CITY OF LA VISTA
MAYOR AND CITY COUNCIL REPORT
JULY 19, 2016 AGENDA

Subject:	Type:	Submitted By:
APPLICATION FOR PRELIMINARY PLAT, LOTS 1-7, BRENTWOOD CROSSING, LOTS 8B & 8C, BRENTWOOD CROSSING REPLAT NO. 1, LOTS 8A1, 8A2, 8A3 & 8A4, BRENTWOOD CROSSING REPLAT NO. 2, AND PORTIONS OF TAX LOT 12, 14-14-12; AND WAIVER OF SECTION 4.24, SUBDIVISION REGULATIONS (SE OF 84 TH & SUMMER DR.)	◆ RESOLUTION ORDINANCE RECEIVE/FILE	ANN BIRCH COMMUNITY DEVELOPMENT DIRECTOR

RE: Preliminary Plat – Initial Review
La Vista City Centre

RE: Preliminary Plat – 2nd Review
La Vista City Centre

SHEET
C3.2

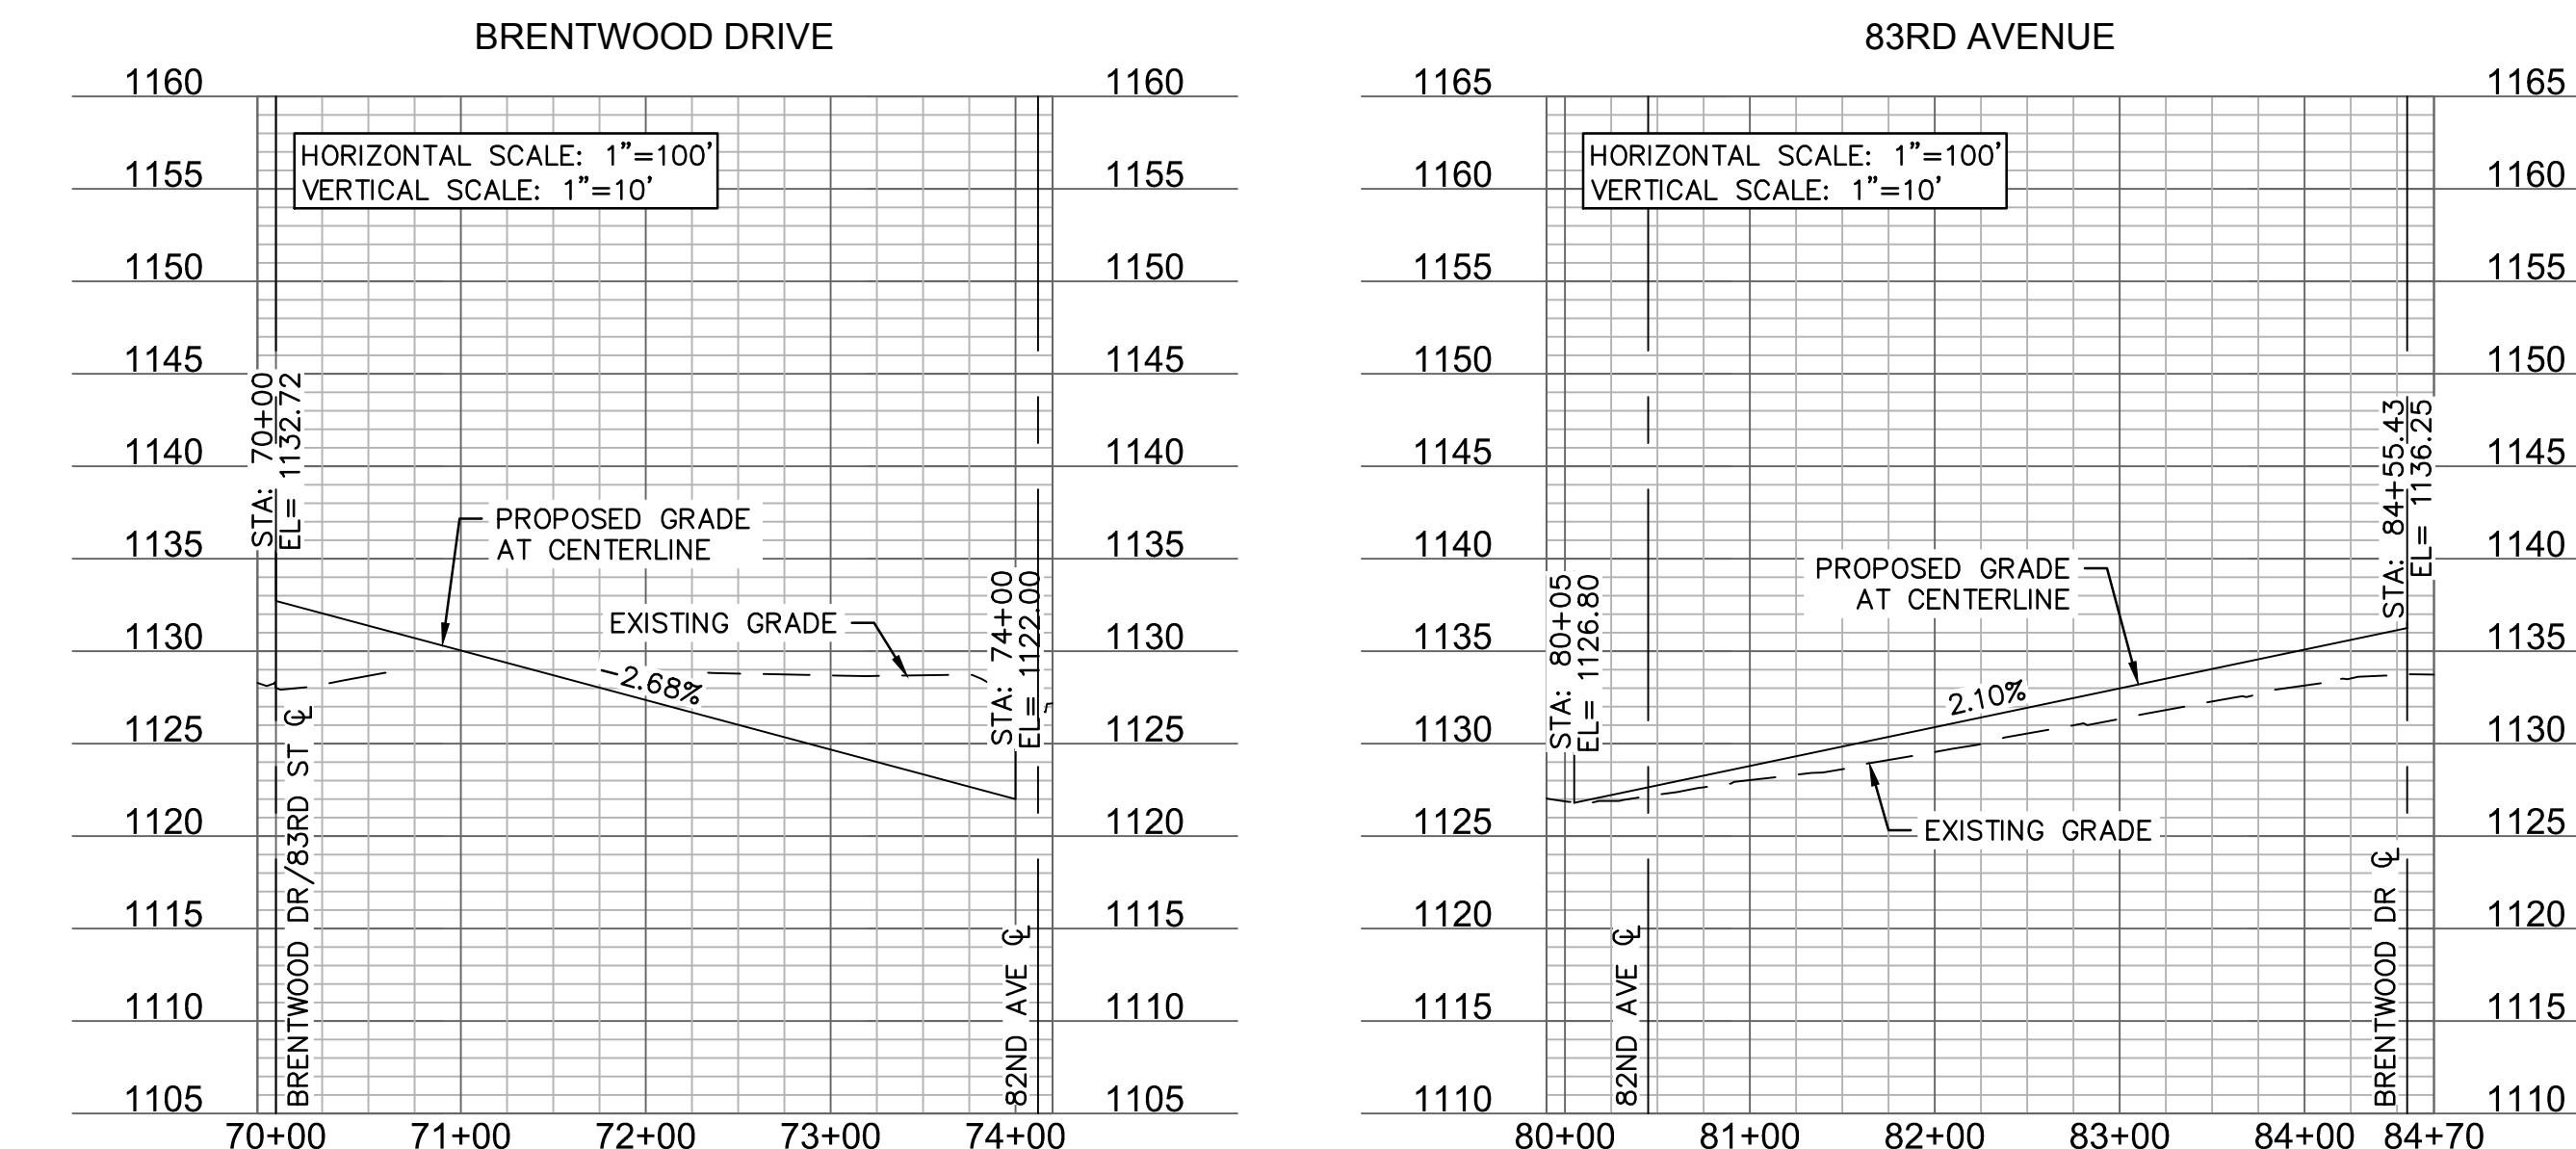
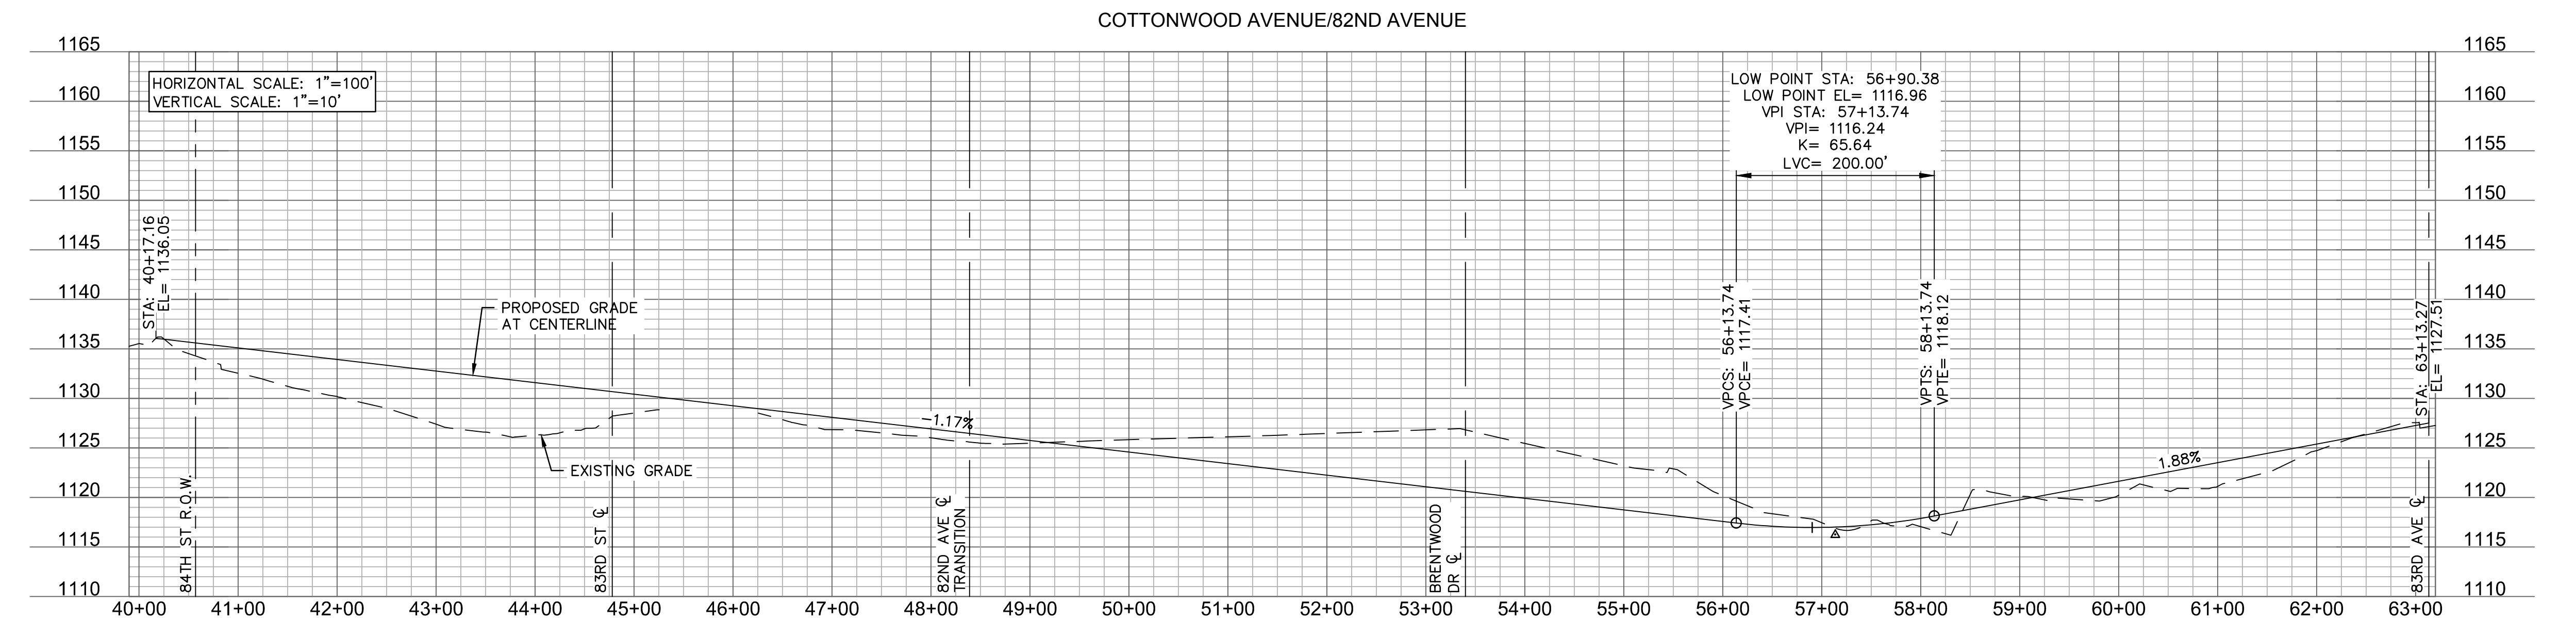
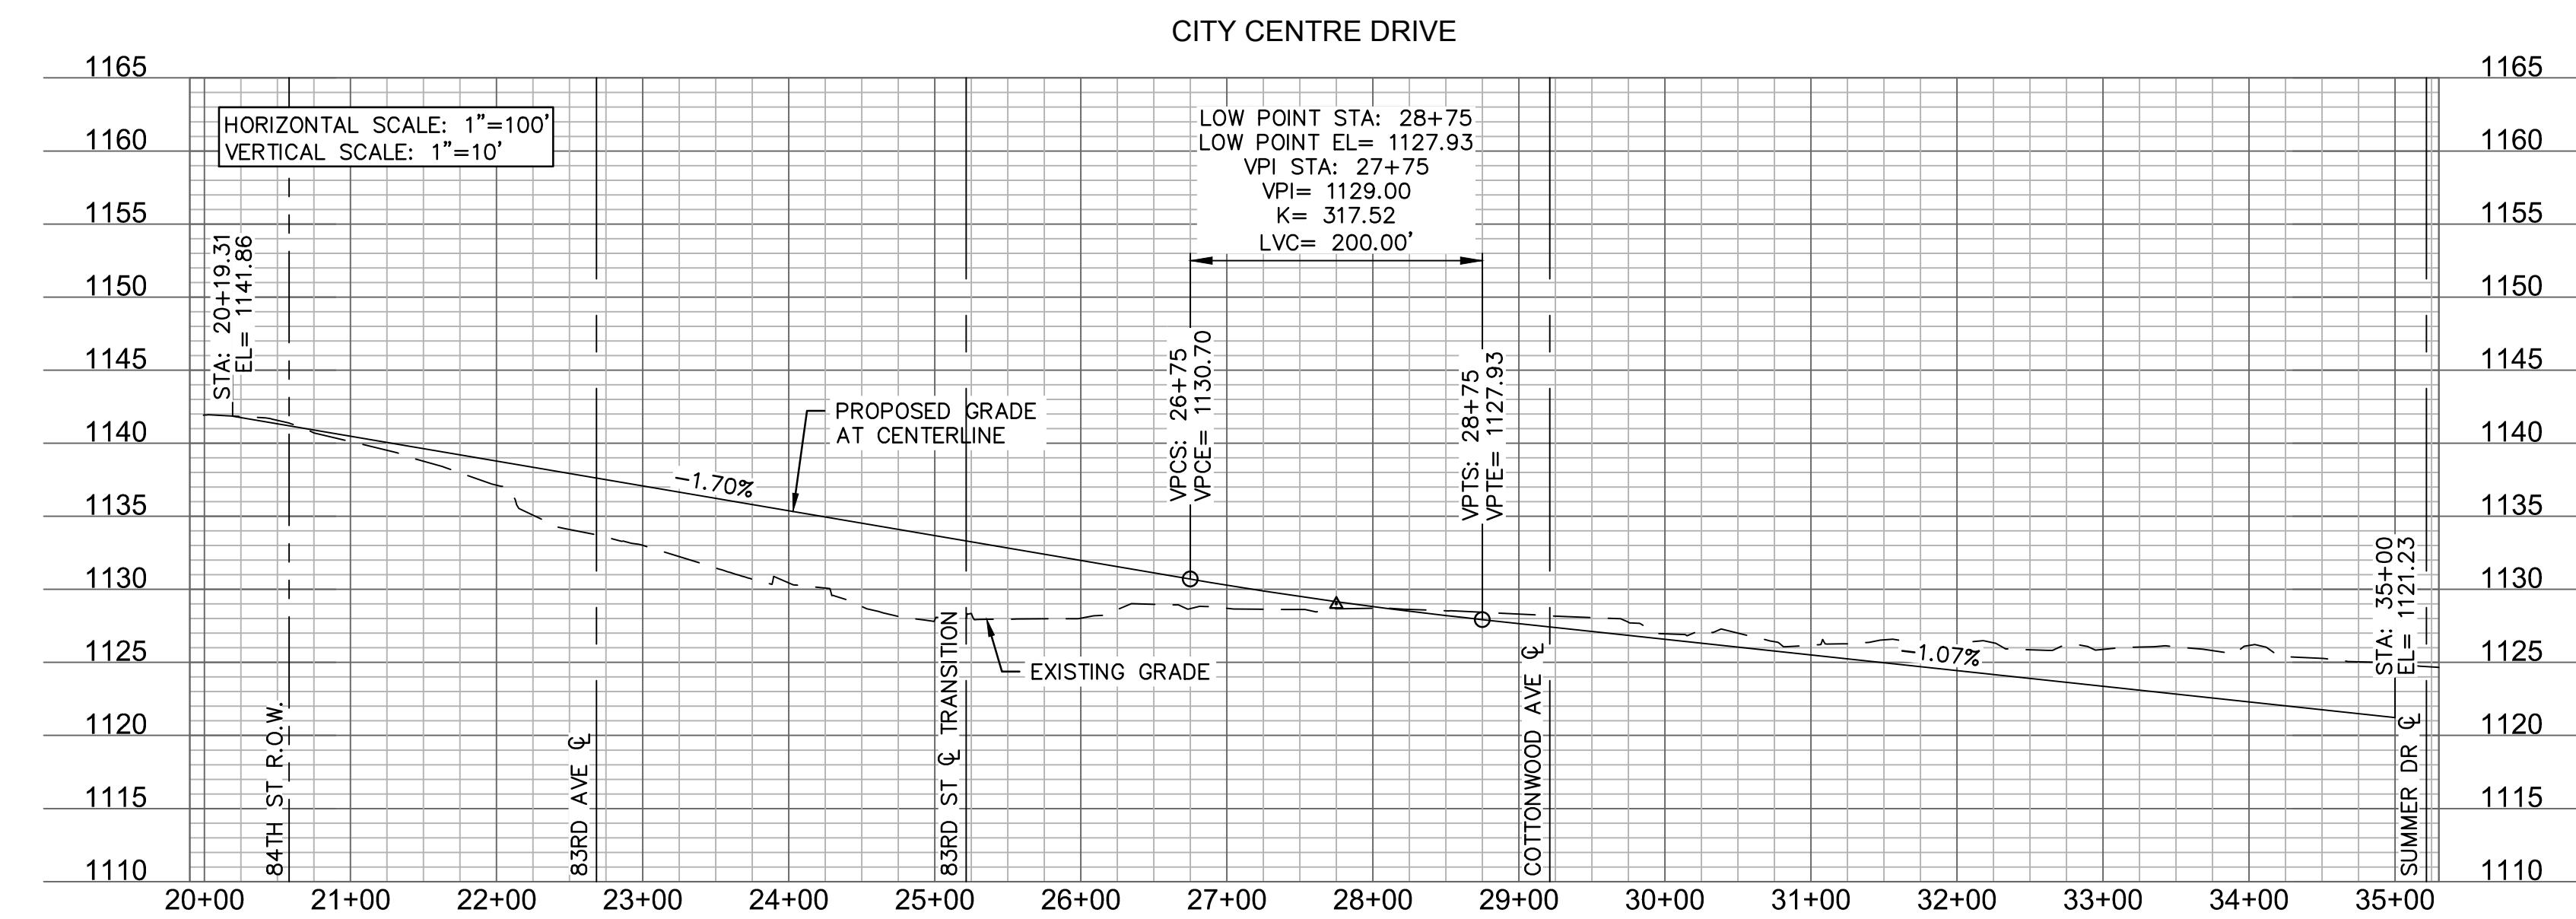
2. On Sheet C3.2 there needs to be a note added stating that a single grading and erosion control permit will be obtained for all lots in the preliminary plat. The fewest number of grading permits is preferred to allow for ease of administration and coordination of inspections as well as reducing permit costs for the applicant.

Response: Note has been added to the plan
